The Banks – Phase 3C
Public Infrastructure Development
Bid Package #2 – Lot 28 Park & Garage
January 13, 2022
THP #98090.40

ADDENDUM #2

DRAWING TITLE
ELM ST. STAIR ELEVATIONS & SECTIONS

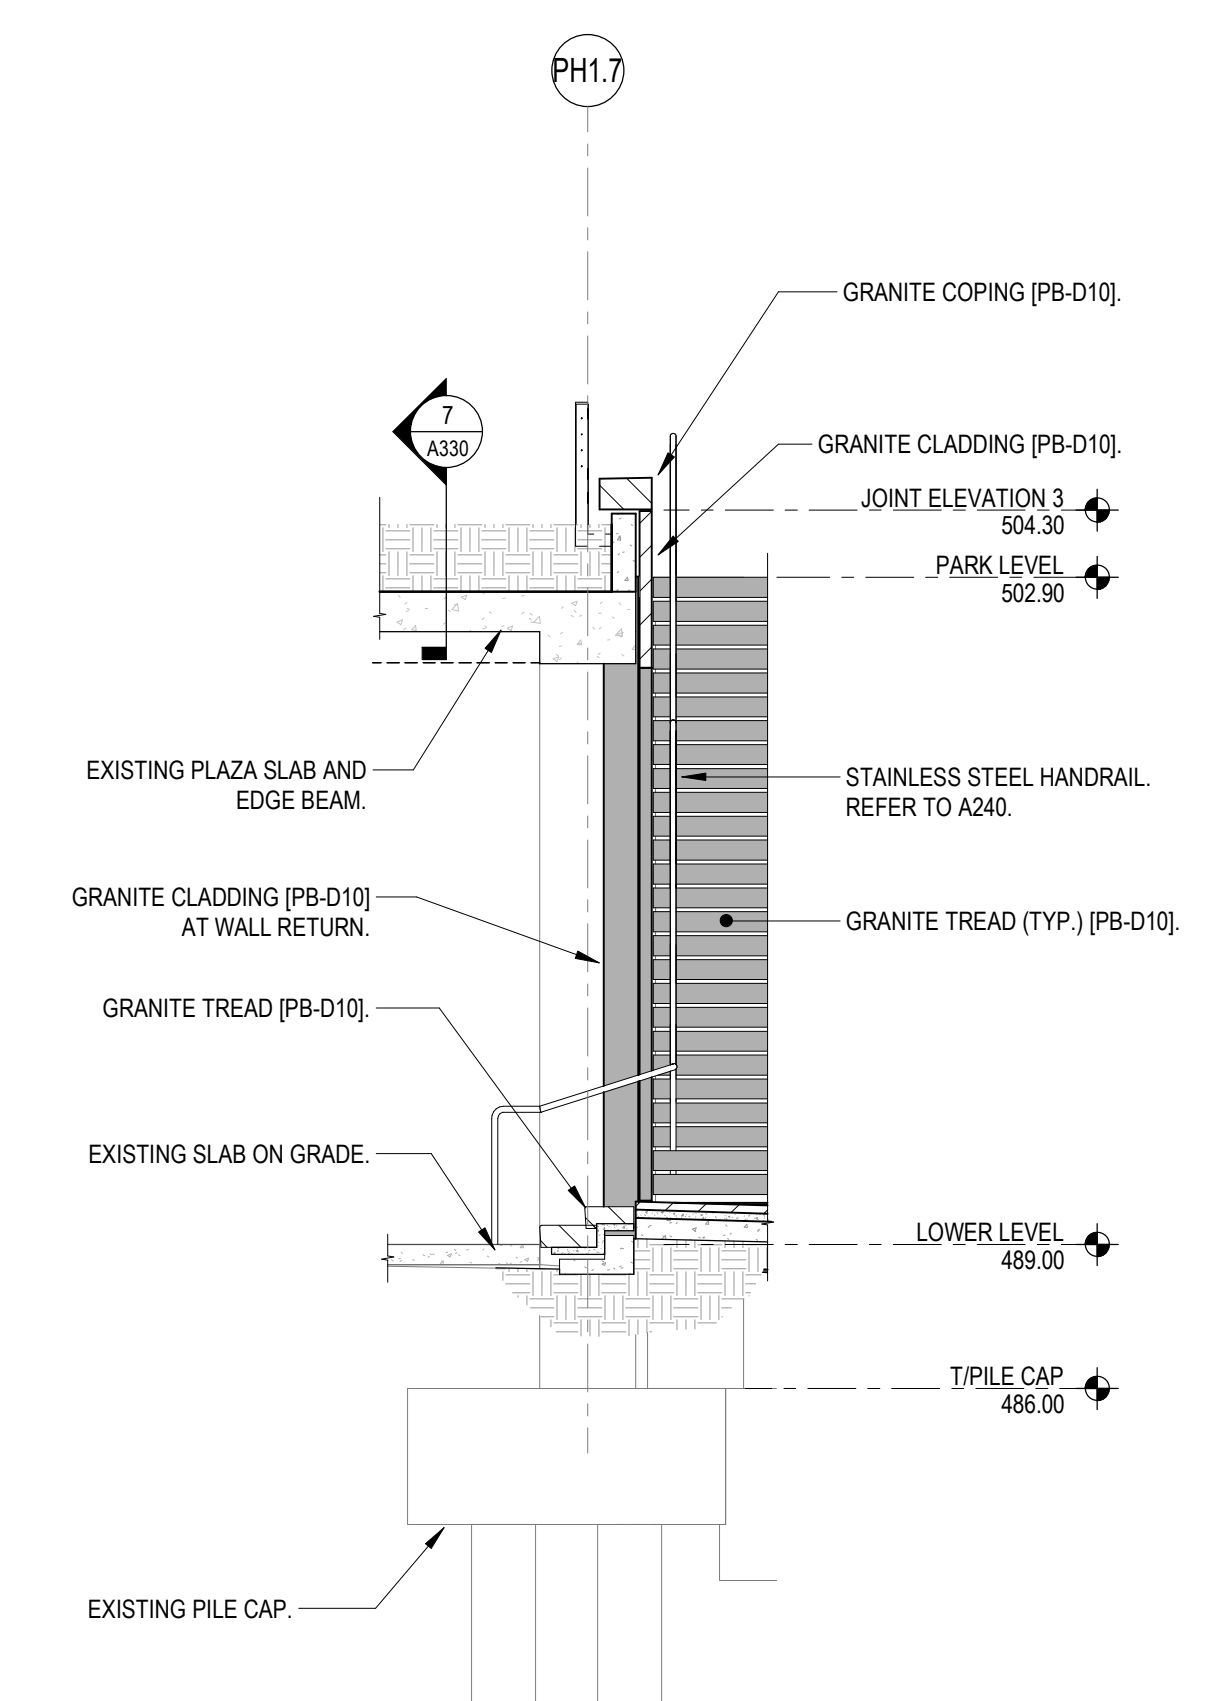
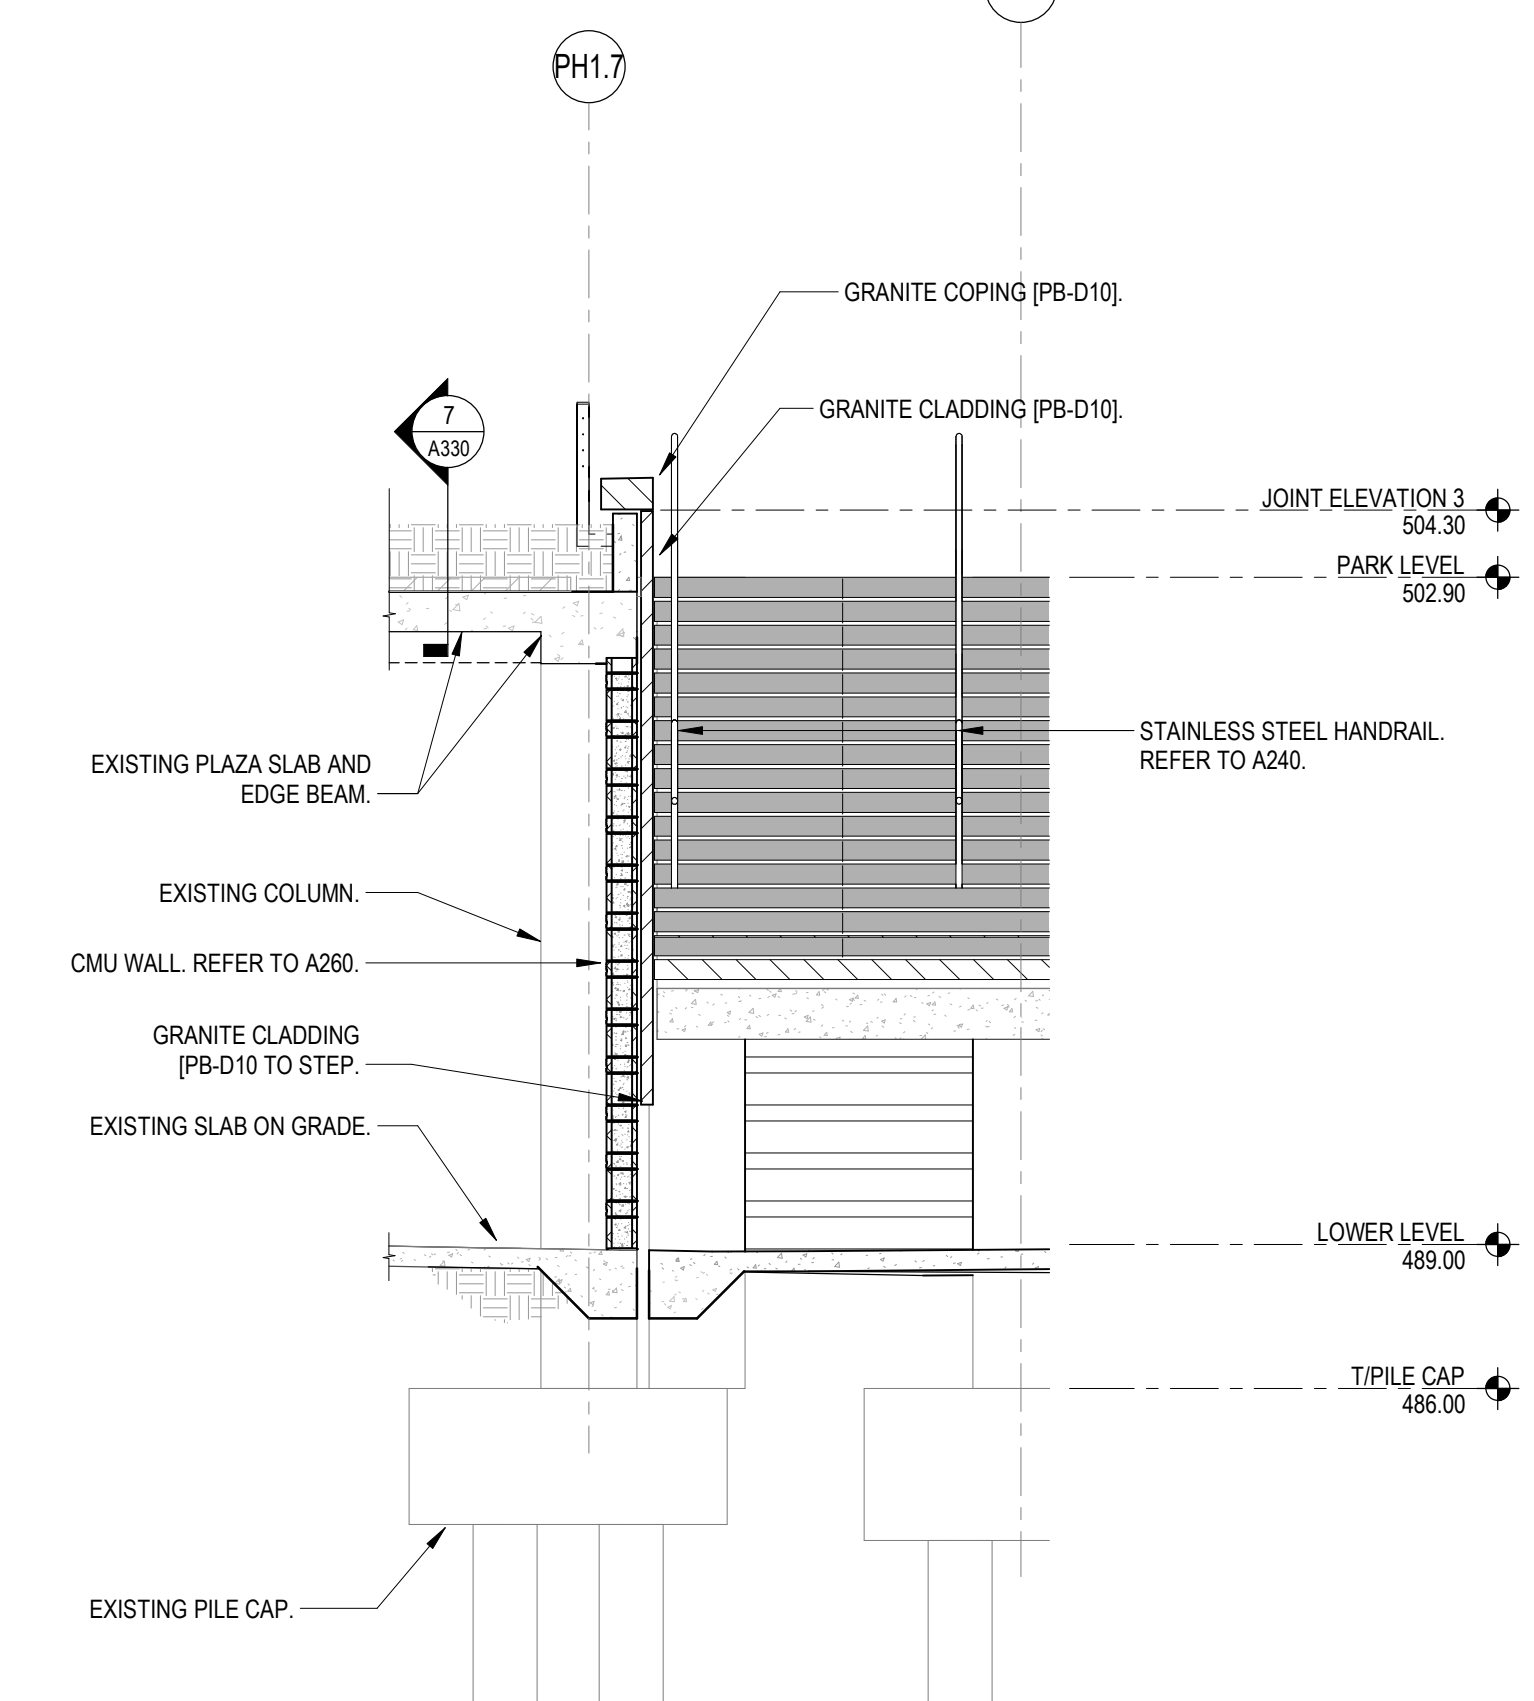
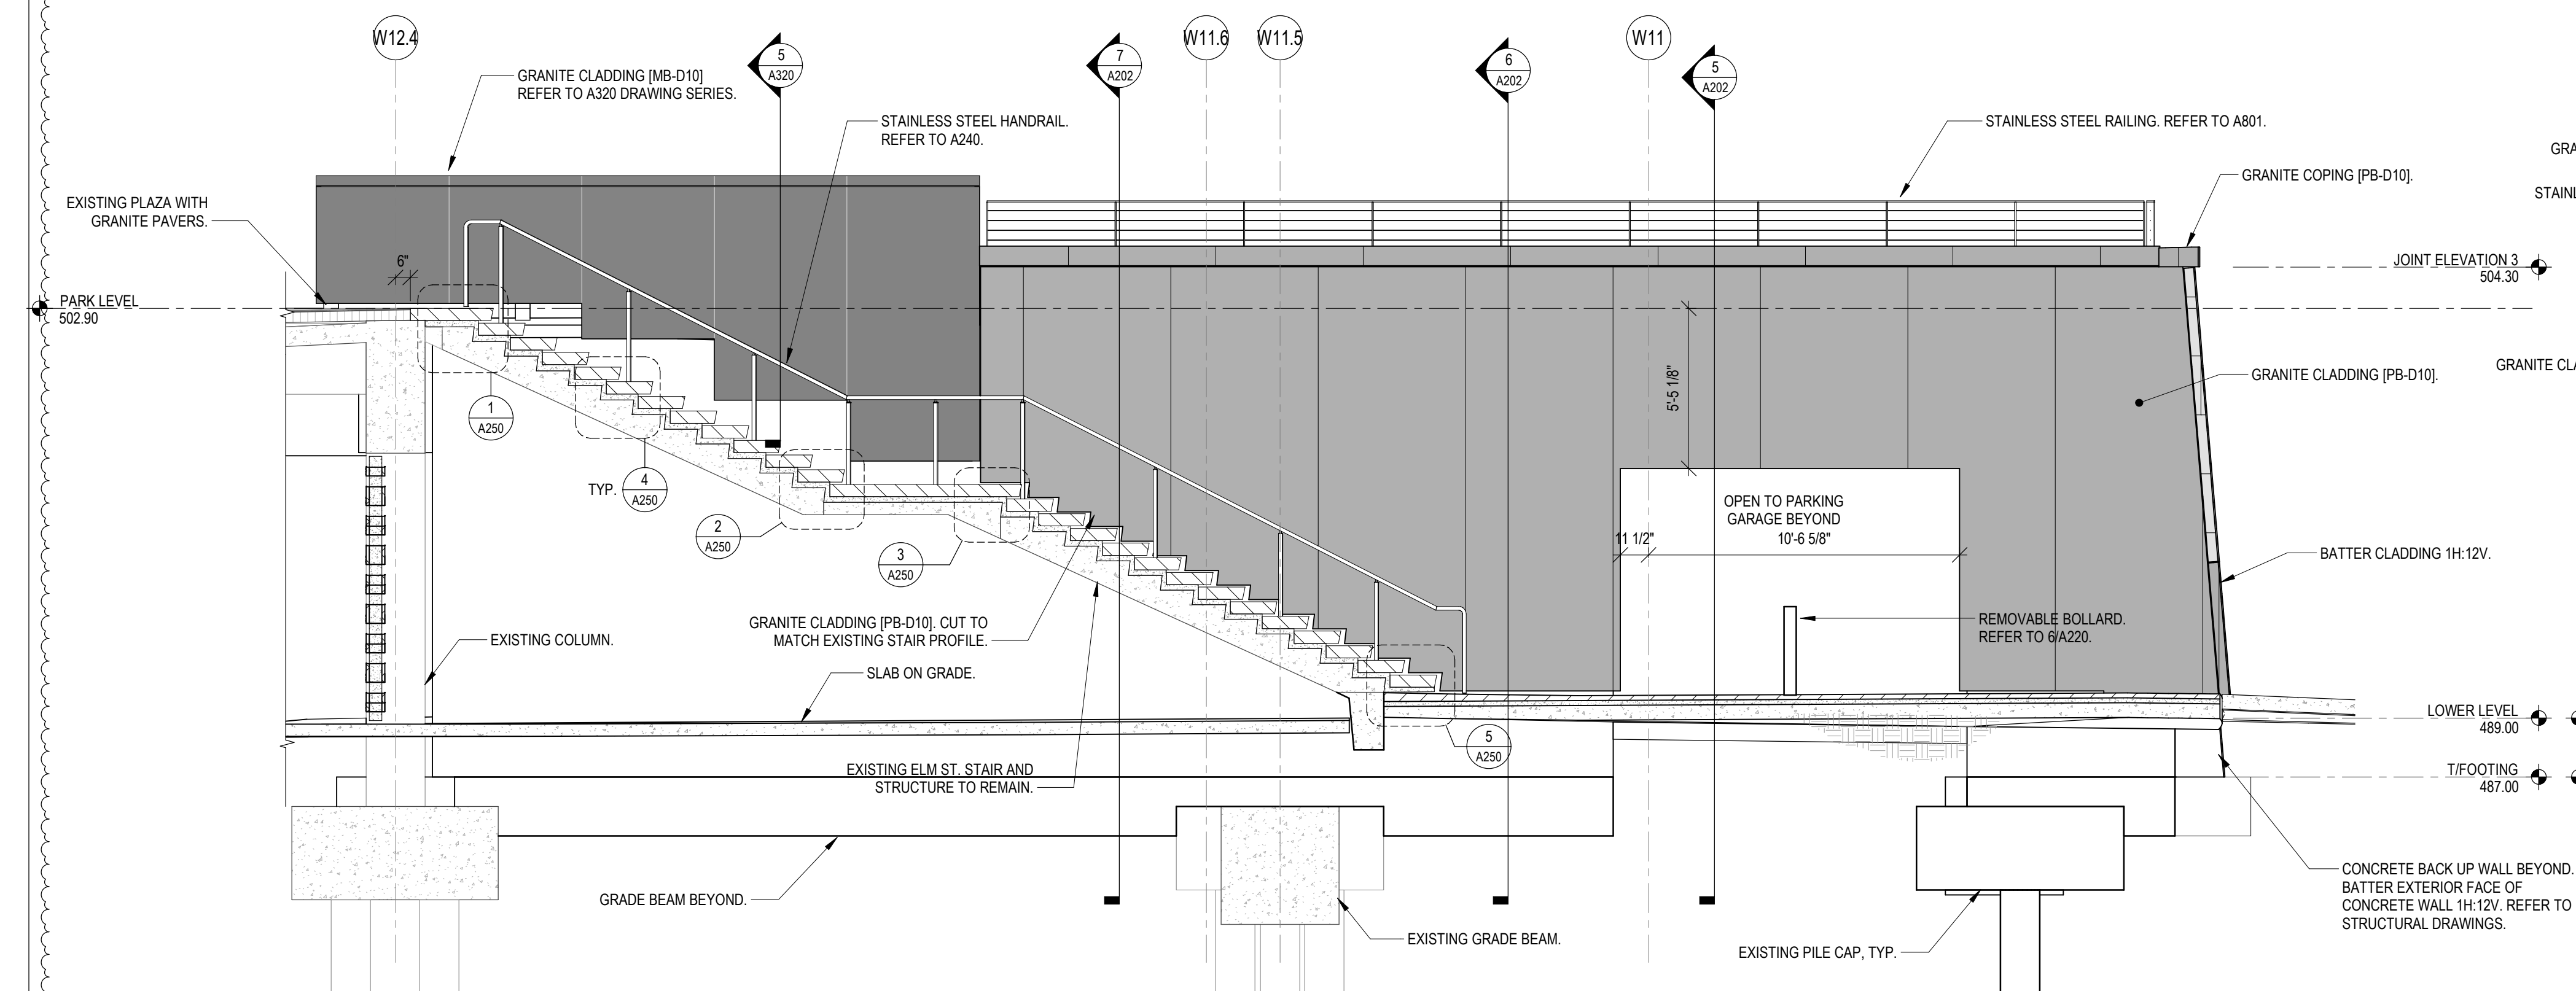
9. **A202** – Please provide top of wall/curb for details 5,6,7. This curb and wall will sit on the upturn beam located at along column line PJ1.
 - **Response to question 9:** See revised Drawing A202 in Addendum #2 and refer to details 10 & 15/S401.
